STAFF REPORT AND RECOMMENDATION TO THE DESIGN COMMISSION

CASE FILE: LU 13-107395 DZM – 0601 SW Abernethy
PC # 12-193194
REVIEW BY: Design Commission
WHEN: April 4, 2013 @ 1:30 pm
WHERE: 1900 SW Fourth Ave., Room 2500A
Portland, OR 97201

A2.4
FLOOR PLAN
UNIT LEVELS 2-6 (TYP.)

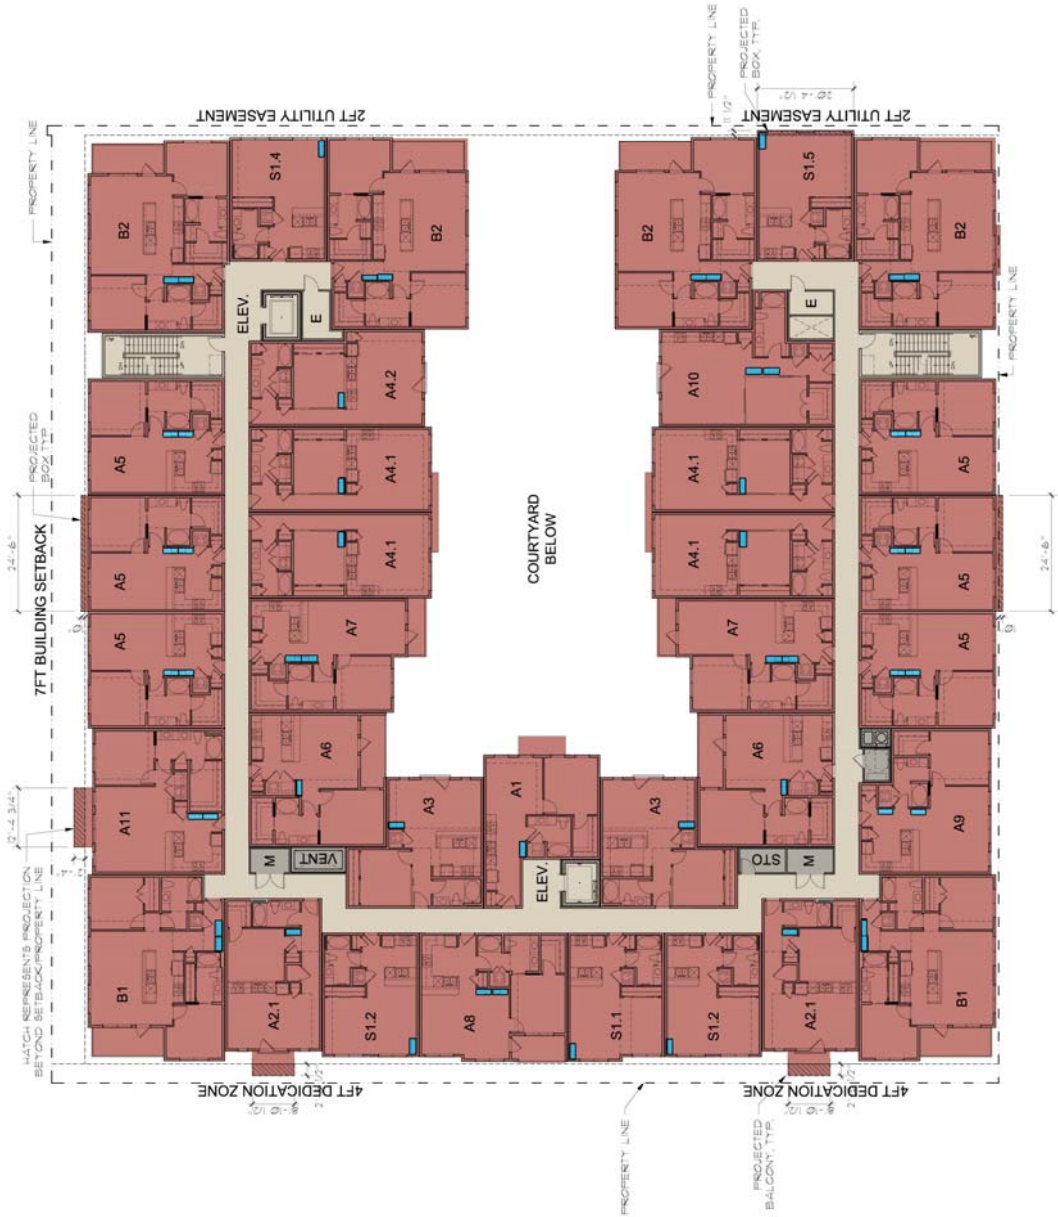
In addition, staff notes that many of the designated long-term bicycle parking spaces inside the units are located within egress paths to the unit doors. Staff does not feel that these are acceptable areas for long-term bicycle parking and these must be shown in more logical locations, where they will not create barriers to the path of egress, if they are to be counted among the required long-term bicycle parking spaces.

02 WEST ELEVATION S.W. MOODY
SCALE: 1/8" = 1'-0"

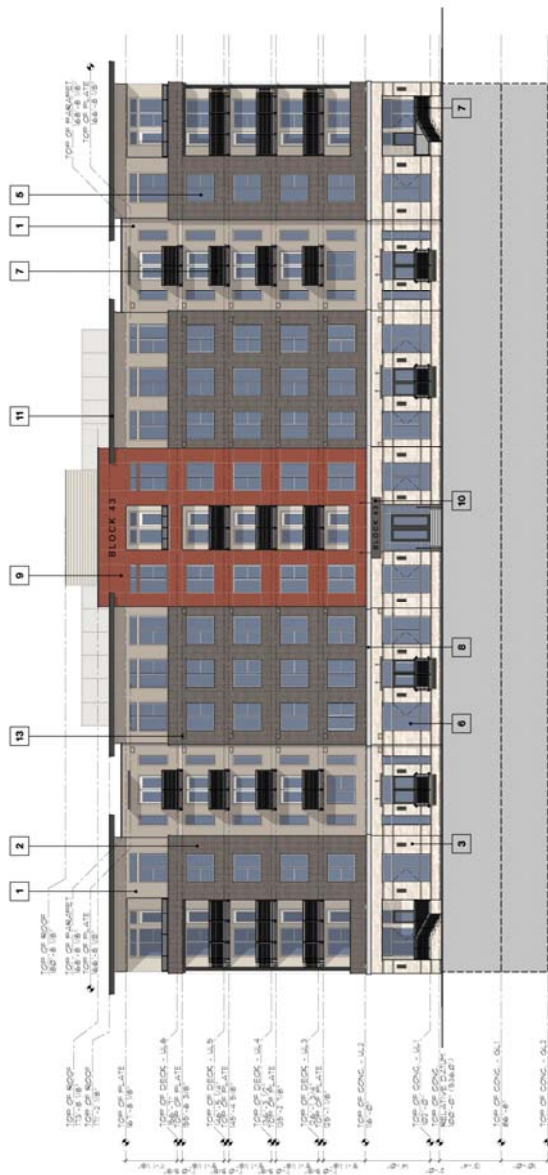
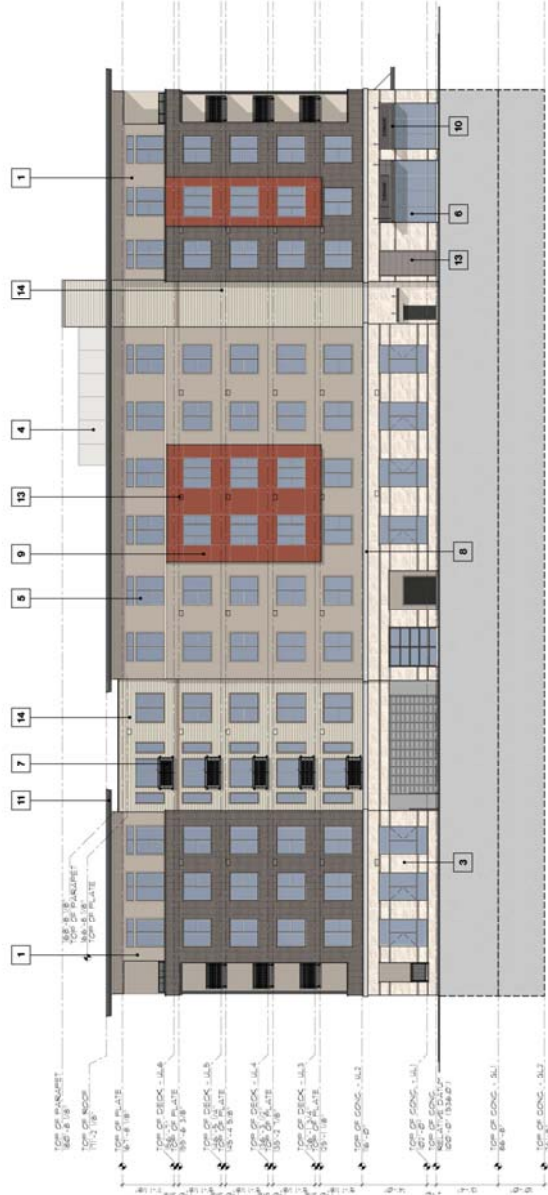
Other than SW Bond, SW Moody, on the west side of the building, will receive the most pedestrian traffic. At the ground level, the applicant is proposing recessed stoops at the corners with Juliet balconies at some of the other units. Floor to ceiling windows will provide ample views between the interior and exterior. This elevation will also have projecting balconies, as well as recessed balconies at the corners. Originally, the applicant had intended on providing stoops along this elevation, however, due to the required dedication of 4'-0" of additional right-of-way, the stoops were lost in order to retain interior living space. Staff has continued to encourage the applicant to reintroduce the stoops at the ground level units, at the expense of interior square footage if need be. The applicant has applied for a Revocable Encroachment Permit to allow side-facing entrance stoops within the 2'-6" frontage zone along SW Moody. At the time of writing this staff report, PBOT's approval or denial was not yet known, however this question should be answered in time for the hearing on April 4th. If approved, the applicant will revise the drawings to show stoops along this frontage. If the stoops are not approved, staff is supportive of the Juliet balcony option shown in the drawing package. At the center of this elevation is a recessed and elevated entrance, secondary to the main entrance on SW Bond. Through the glass doors of this entrance, pedestrians will be able to look straight through the building's secondary lobby to the interior courtyard, providing added interest to this elevation.

Exterior lighting in the courtyard is shown to be string lighting in a regular parallel pattern. This regularity will add contrast to the irregular plan of the courtyard, adding an extra dynamic layer to the overall courtyard composition. Lighting is proposed at the sides of all windows and doors on SW Moody as shown in detailed elevation drawings on A4.3 and A4.4, as well as in the renderings, particularly A6.9. Staff feels that the proposed light fixtures are excessive in size, and possibly number, especially since SW Moody is considered, by the

applicant, to be the secondary façade. Staff also notes that no lighting is shown for the retail side of the building along SW Bond, where pedestrians are expected to be greater in number. Staff encourages additional exploration of the overall lighting system and reiterates support for the string lighting in the courtyard.
